Powerlink Queensland

Theodore Wind Farm Connection Project

Ministerial Infrastructure
Designation - Response to
Consultation Submissions &
State Agencies
Submissions

Figure 3.4 Warrants for turn treatments on major roads at Dawson Highway / Leichhardt Highway intersection (Scenario 1)

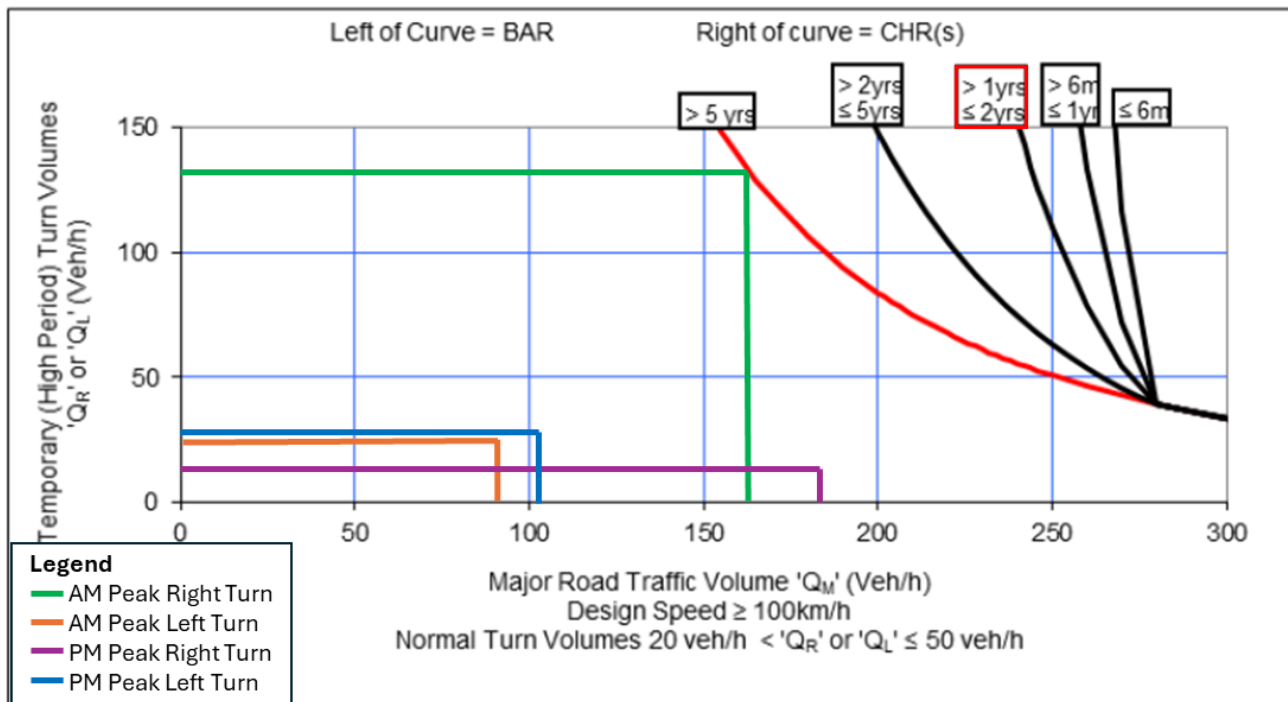
Submission	Response
Amend the provided SIDRA model and apply the correct posted speed to the Leichhardt Highway intersections with Defence Road and Uncle Toms Road and provide the electronic SIDRA file.	The SIDRA models have been updated to incorporate the correct posted speed limits for the Leichhardt Highway intersections with Defence Road and Uncle Toms Road. Updated modelling confirms that the revised speed inputs do not materially alter the assessment conclusions. Detailed methodology and results are provided in Section 2 – SIDRA Update, with full SIDRA outputs included in Appendix A. An electronic SIDRA file can be provided to TMR.
Provide a turn warrant assessment for the construction traffic volumes in accordance with TMR’s Technical Note 199 ‘Guidance for the design of temporary roads’, dated December 2021 to demonstrate suitability of the existing turn treatments at all three (3) SCR intersections related to this development. Where any intersections do not comply with this technical note, provide conceptual layouts for the required intersection upgrade works.	A turn warrant assessment has been completed for the three State-controlled road intersections in accordance with TMR Technical Note 199 (December 2021). The assessment confirms that the existing turn treatments are appropriate, and no intersection upgrades are required. Further details are provided in Section 3 – Turn Warrant Assessment in Appendix A.

The turn warrant assessment results for the Dawson Highway / Leichhardt Highway intersection under Scenario 1 are shown in Table 3.1 and Figure 3.4. This shows:

PS218956-WSP-CIV-0151

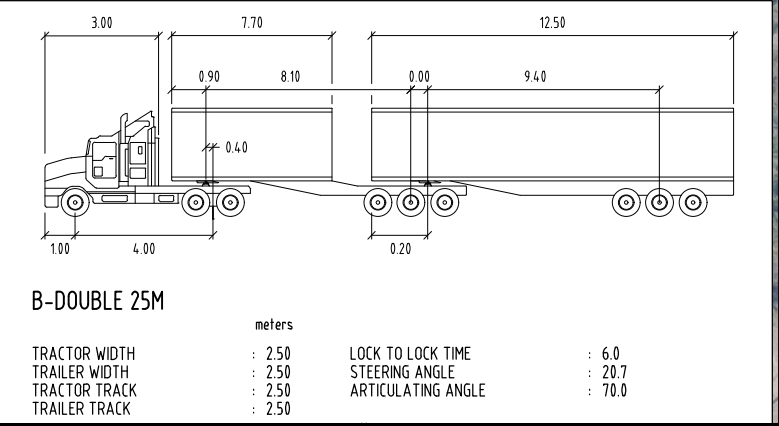
In accordance with RPDM Supplement to 4A s 7.2.2, provide a conceptual layout to upgrade the existing AUR for the Dawson Highway / Leichhardt Highway to a channelised right turn (short) (CHR(s)) turn treatment.	A conceptual layout has been prepared for Dawson Highway / Leichhardt Highway intersection. Please review Section 4 – Conceptual Layouts, with drawings included in Appendix B of Appendix A.
Provide a conceptual layout of the Leichhardt Highway / Uncle Toms Road intersection for the required upgrade work to facilitate a minimum 20m long sealed section of Uncle Toms Road. The required extent of the seal must be demonstrated by providing turn paths of the proposed design vehicle.	A conceptual layout has been prepared for the Leichhardt Highway / Uncle Toms Road intersection, including a minimum 20 m sealed section of Uncle Toms Road and demonstration of vehicle turn path requirements. Please review Section 4 – Conceptual Layouts, with drawings included in Appendix B of Appendix A.
